System Impact Assessment Report (Addendum)

**Raleigh
Wind Generation Station (WGS)**

CAA ID 2007-268

June 17, 2010

Figure 2: New Proposed Raleigh WGS

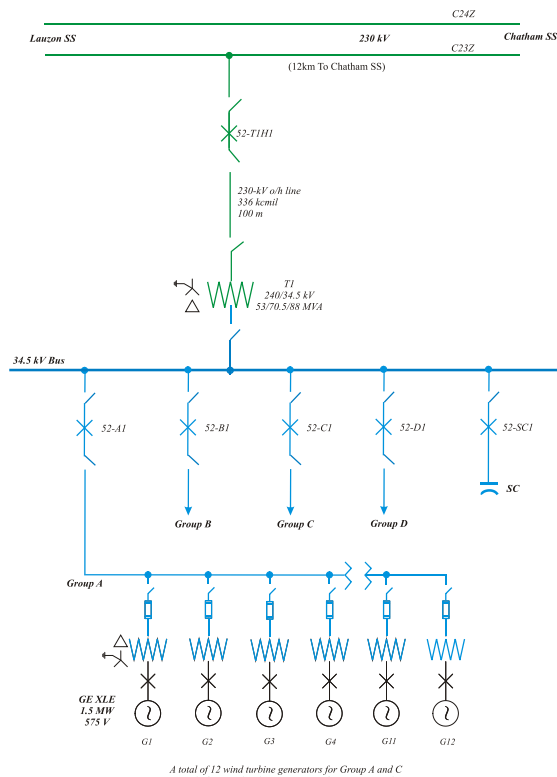
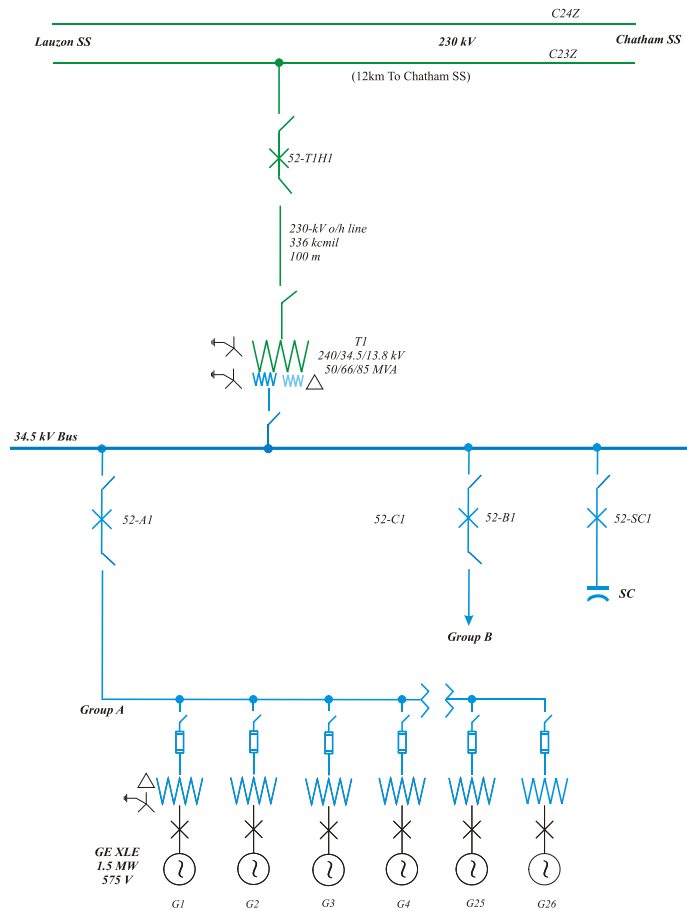
The System Impact Assessment for Raleigh WGS was completed (CAA ID 2007 - 268) on November 27, 2009. Recently, the connection applicant (CA) has submitted a modified design of the Raleigh WGS to the IESO. The number of feeders is to be reduced from four to two in the WGS with the same total number of wind turbines. The originally and new proposed connection arrangements are shown in Figure 1 and Figure 2, respectively.

Figure 3: Results for Inductive Capability Test

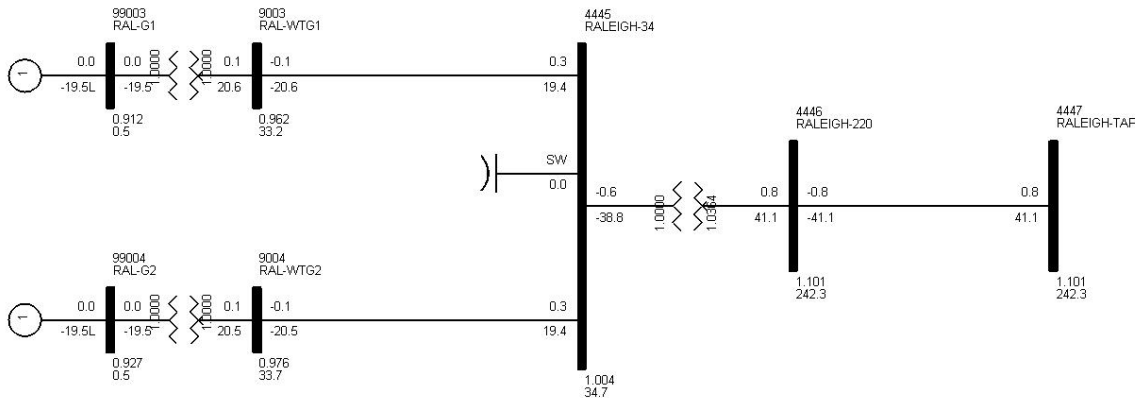
The simulation results in Figure 3 showed that the generation facility can absorb a maximum reactive power of **41 MVar** at the connection point, indicating that Raleigh WGS meets the reactive power in leading p.f. requirement.

Figure 4: Results for Capacitive Capability Test – Before Compensation

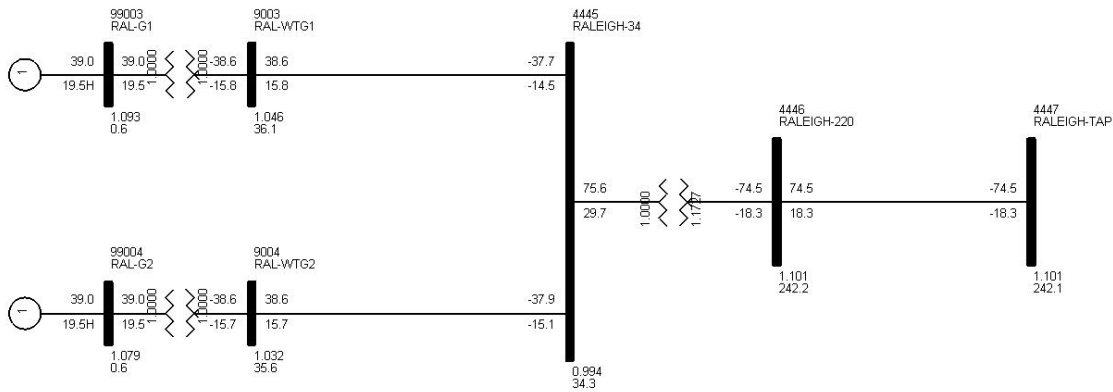
The results in Figure 4 show that the generation facility can supply a maximum reactive power of **18.3 MVar** at the connection point. This indicates that static reactive compensation is required to be installed at the collector bus to meet the reactive power in lagging p.f. requirement.

Based on the equivalent parameters for the WGS provided by the connection applicant, an amount of 9 MVar of static reactive power compensation is required to be installed at the WGS collector bus to meet the reactive power requirements at the connection point.

Figure 5: Results for Capacitive Capability Test – After Compensation

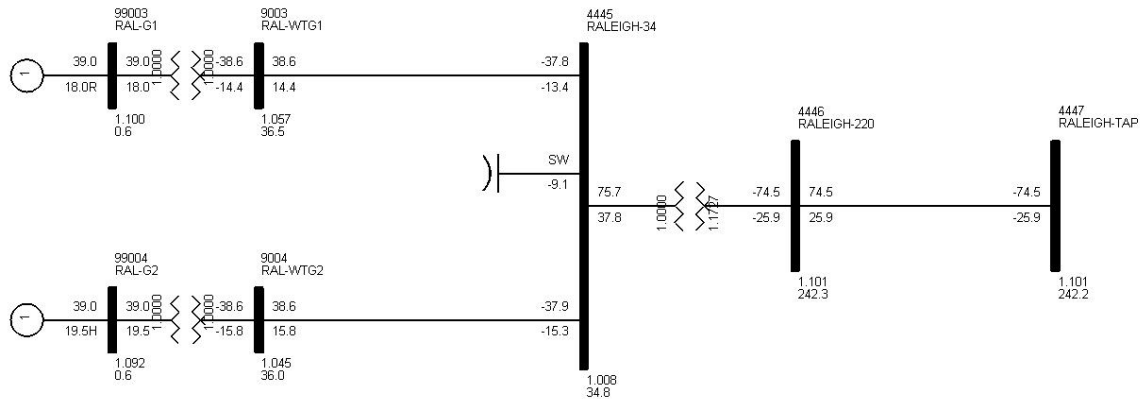
As shown in Figure 5, one capacitor bank, with a capacity of **9 MVar@34.5 kV**, installed at the 34.5 kV bus will increase the reactive power injection at the connection point. With this capacitor bank, the wind farm can supply a maximum reactive power of **+25.9 MVar** at the connection point, which meets the capacitive reactive power requirement.
